BULLETIN #8

DATE:	January 19, 2024	
TO:	Laura Li Industries, LLC Attn: Vincent Sessano	list
FROM:	Brian Dunn, AIA KG+D Architects, PC	
PROJECT:	Harrison Recreation & Community Center – PHASE 1 Harrison, NY	
RE:	Revised Geothermal Well Layout- Reference M-401 and M-40	02

BULLETIN #8R

DATE:	January 24, 2024
то:	Laura Li Industries, LLC Attn: Vincent Sessano
FROM:	Brian Dunn, AIA KG+D Architects, PC
PROJECT:	Harrison Recreation & Community Center – PHASE 1 Harrison, NY
RE:	Revised Geothermal Well Layout- Reference M-401 1/19/24

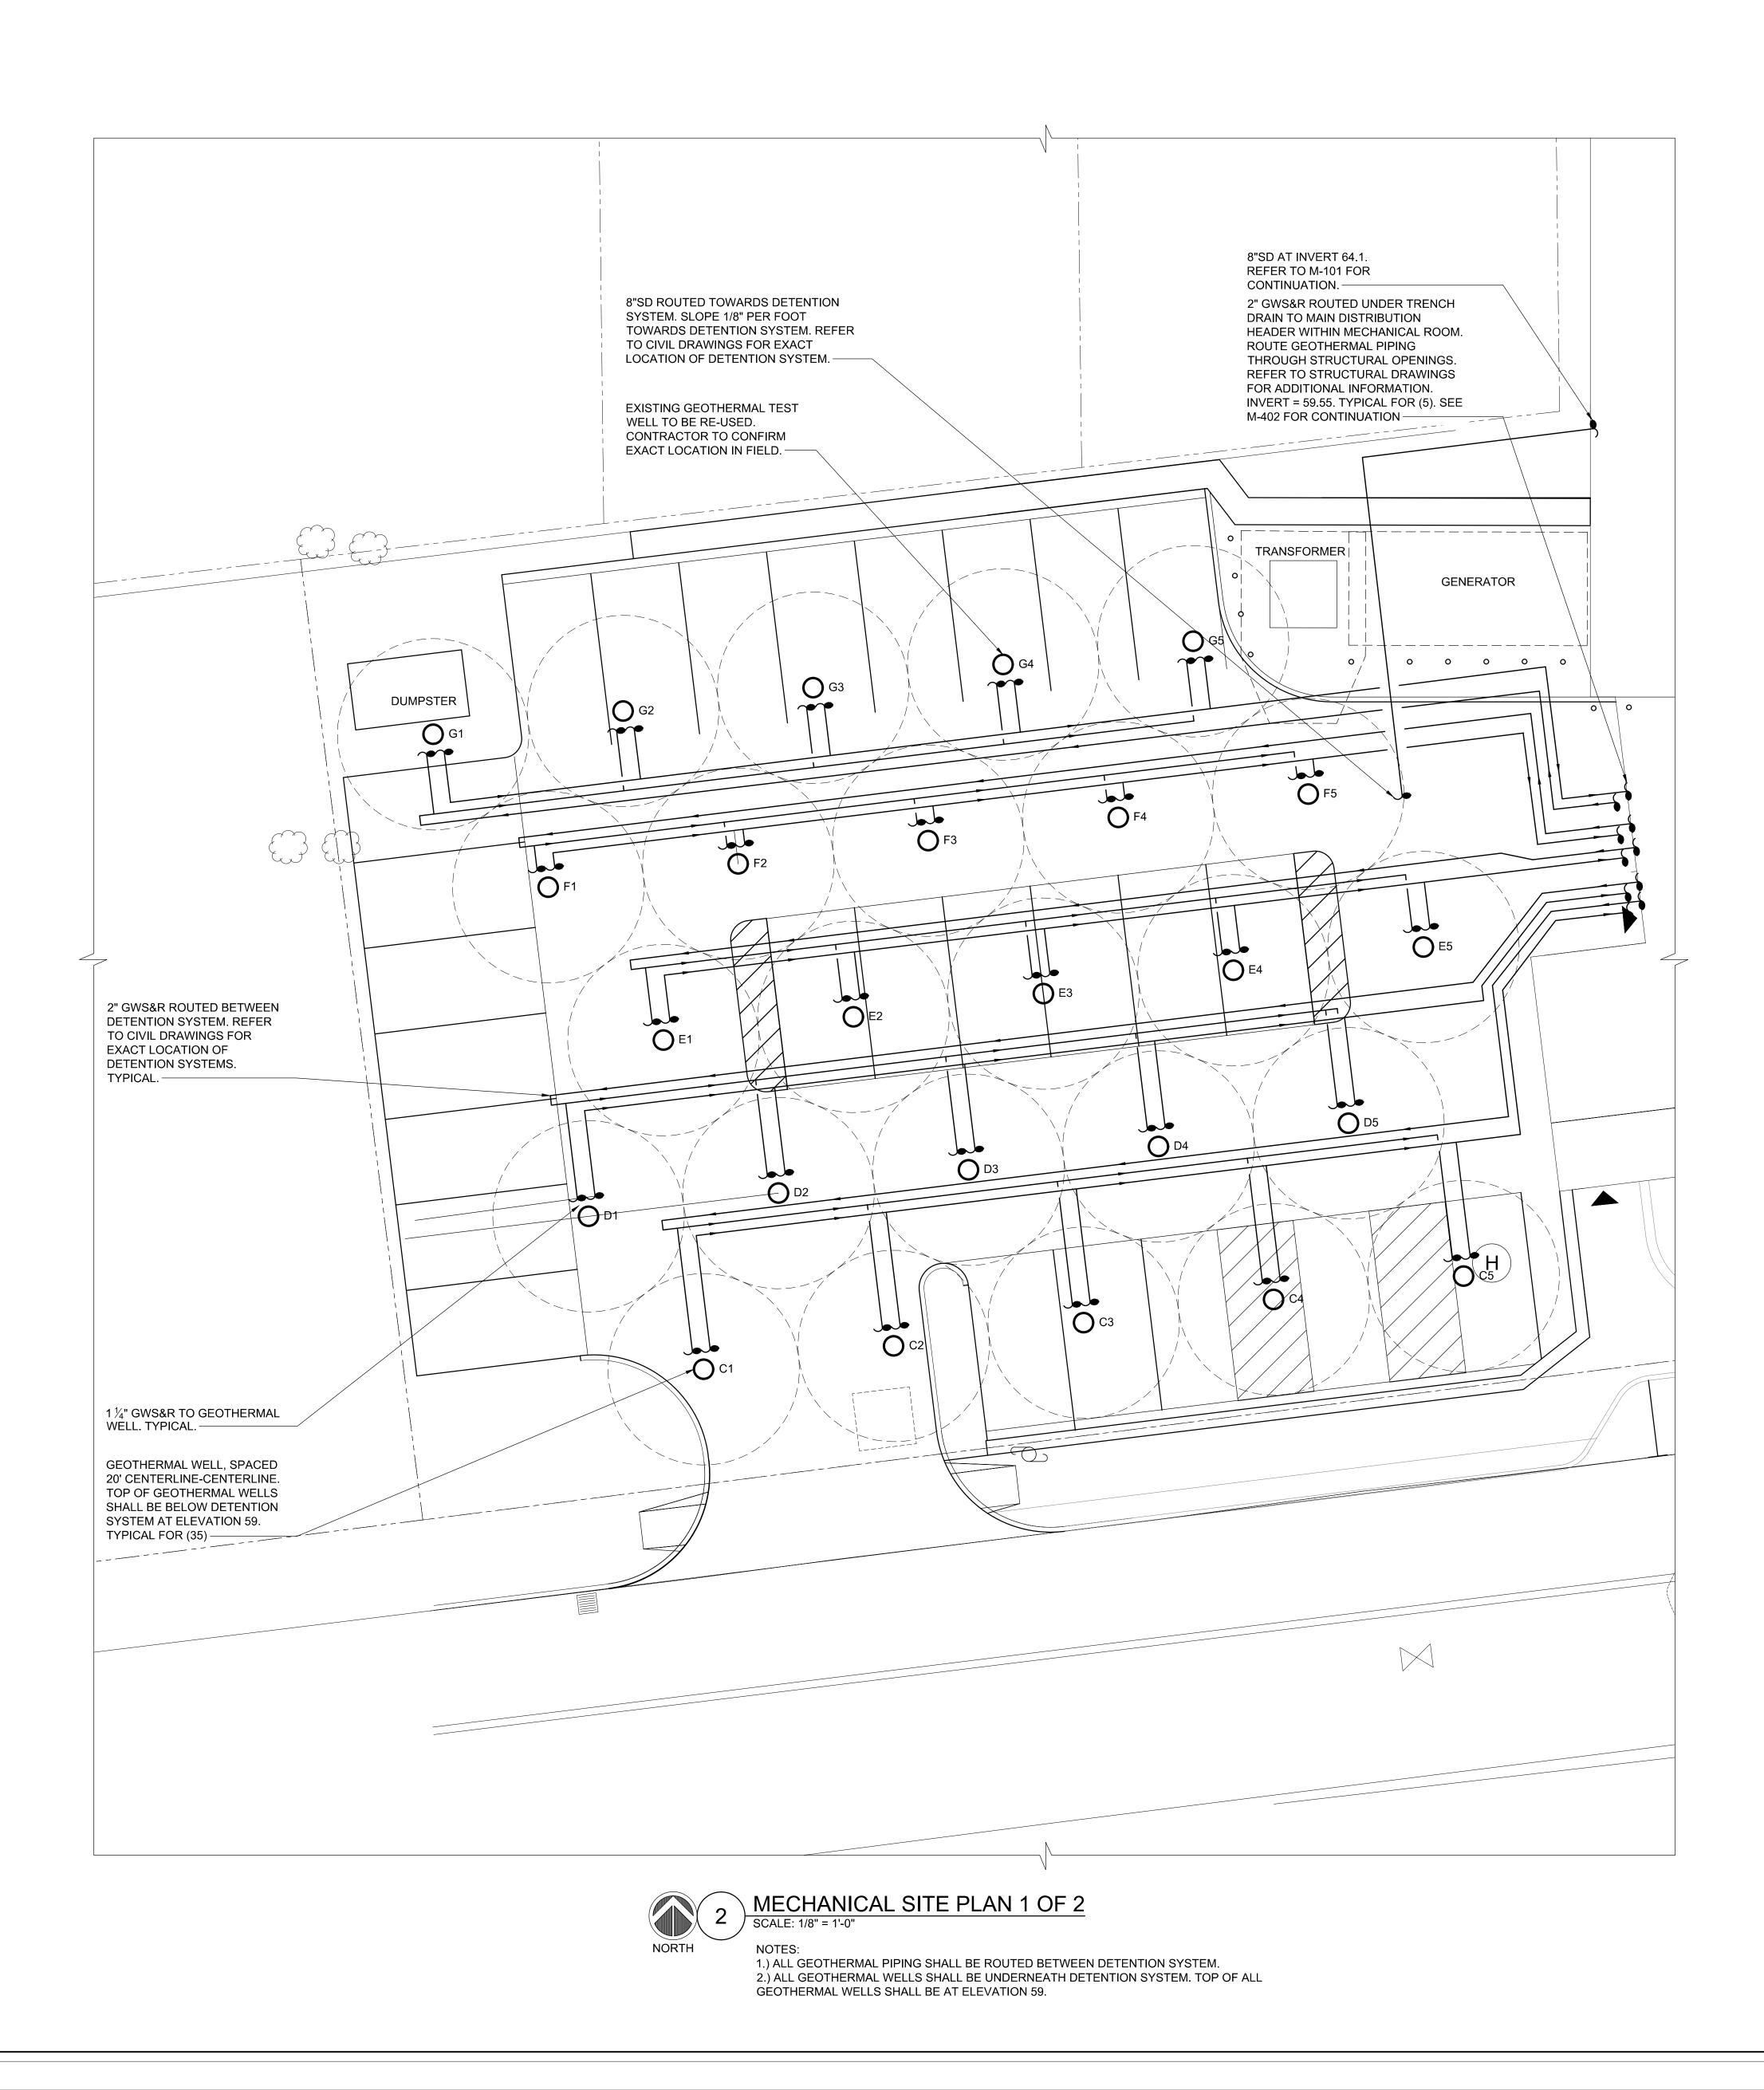
See revised geothermal well layout per M-401 and M-402 dated 1/16/24. Note that all well locations are to maintain a 10' clearance from the property lines, perimeter foundation walls, and/or piers. See M-402 for revision to piping layout within the building footprint.
